PROPOSAL FOR NC RFG REQUIREMENTS OF GENERAL APPLICATION

Public consultation 15 March – 23 April 2018

Figure 1 : Graphical representation of the proposed maximum capacity thresholds.

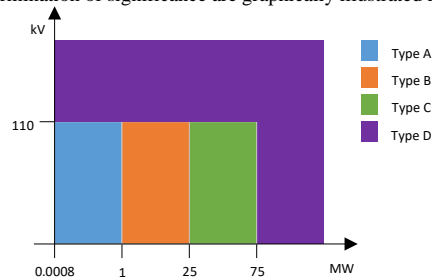
Commented [A4]: We do not agree that assets between 25MW and 75 MW connected above 110 kV are seen as Type D units.

Commented [A5R4]: For more information we refer to *Response of BGA (Belgian Generators Associations) to the public consultation on maximum capacity thresholds for types B, C and D PGM's*, as organized by Elia

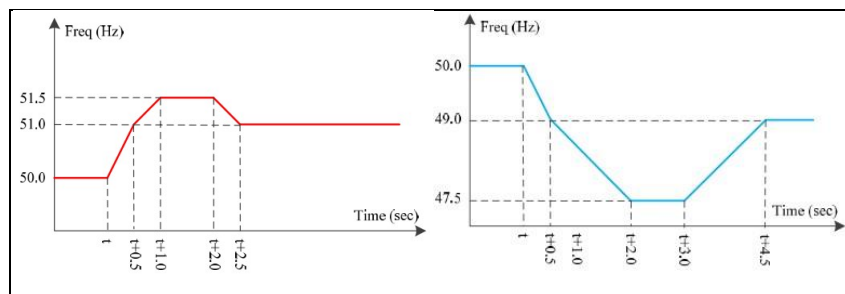
Commented [A7]: Is it possible to combine these time windows? In other words if the frequency stays above 47,5Hz does one needs to stay connected for 30 or 60 minutes. For us this should be 30minutes and thus summarized to 47,5Hz – 49 Hz. As problems will occur with connected engines and generators (increasing flux leading to heating of the stator).

Commented [A8]: How can frequency be local?

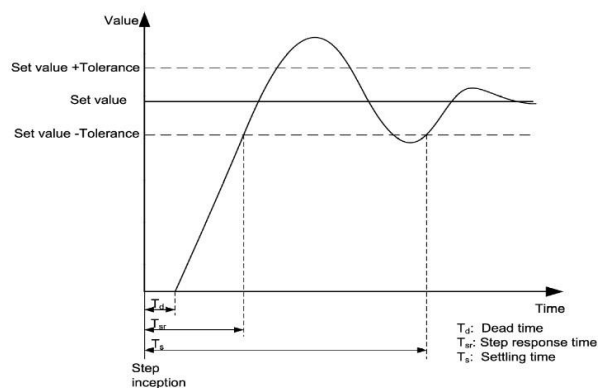
Commented [A11]: LOM is a protection of the generator in case of unwanted islanding. If the island load is near the island production the rate of the threshold of 2Hz/s shall be too high to detect the islanding.
Also what about the responsibility?

Figure 6: Clarification of the concept of net and gross measurement.

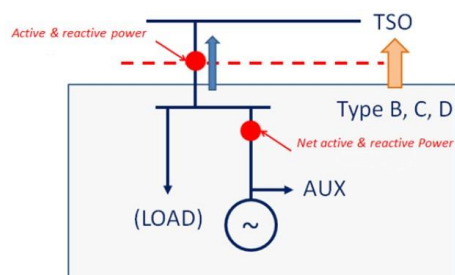
Commented [A29]: This drawing is too simplistic. What about step-up transformers?

Figure 9: FRT requirement for SPGM type B and C

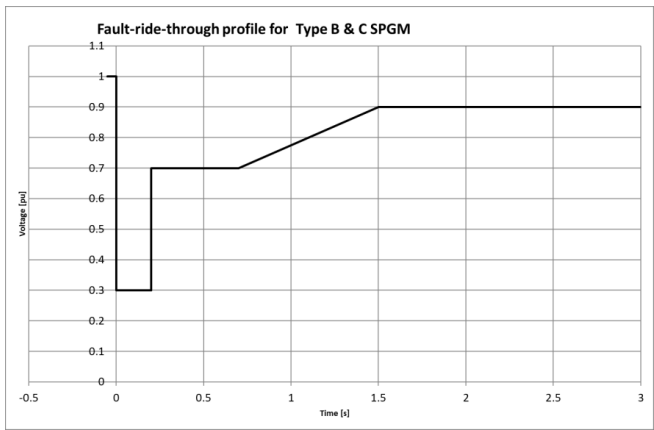
Commented [A33]: Figure is drafted for terminals of alternator. Not at the HV side of the step up transformer.

Commented [A38]: Should be measured at the alternator, not the HV side of the transfo.

Figure 10: FRT requirement for PPM type B and C

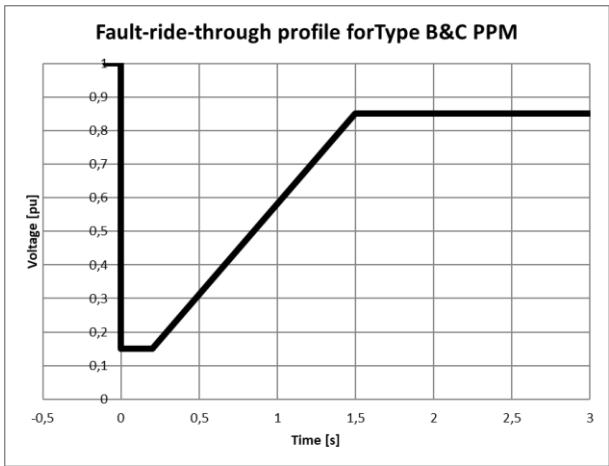
Commented [A42]: Value of 1 pu is missing.

Figure 9-6: Reactive current injection

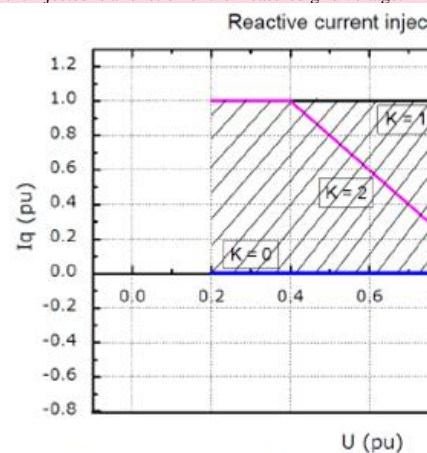
Commented [A52]: We do not inject a zero sequence. I do not see how this is physically possible through a transformer! In Germany the grid codes even forbids to inject a zero sequence.
Proposal: delete the word "zero-sequence".

Figure 15 Active power response capability

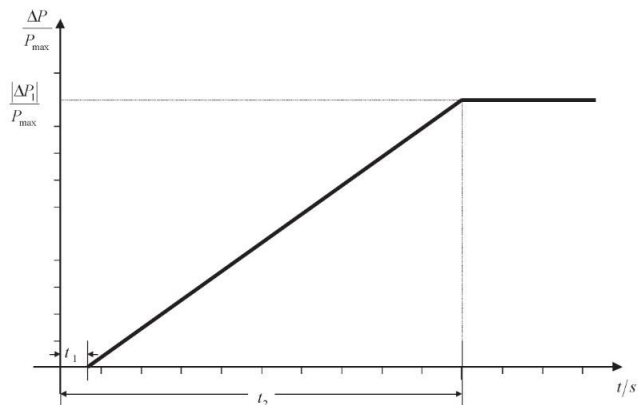
Commented [A63]: We prefer that the current values are maintained.

Figure 17: Capability curve for SPGM type C and D.

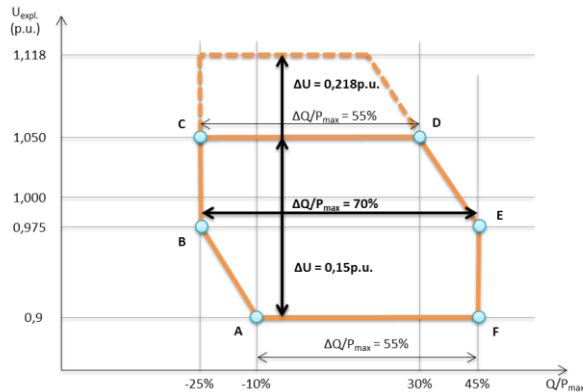
Commented [A77]: This is a value from the old law and has to be modified in coherence with the current requirements for reactive power

Commented [A78]: For consistency best to change to: *the required reactive capabilities should be met at the HV side of the step up transformer if existing; otherwise it should be met at the alternator terminals*

Commented [A79]: RfG (figure 7) imposes a max. value of 1.1 pu. To correct.

Figure 18: Reactive power capability for a Type C and D PPM.

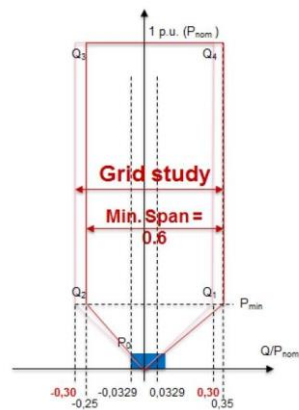
Commented [A81]: Change to: *the required reactive capabilities should be met at the HV side of the step up transformer if existing; otherwise it should be met at the alternator terminals*

Commented [A82]: Not according to RfG figure 8.

Commented [A86]: Avoid repeating the same requirement. (5 times in this paragraph).
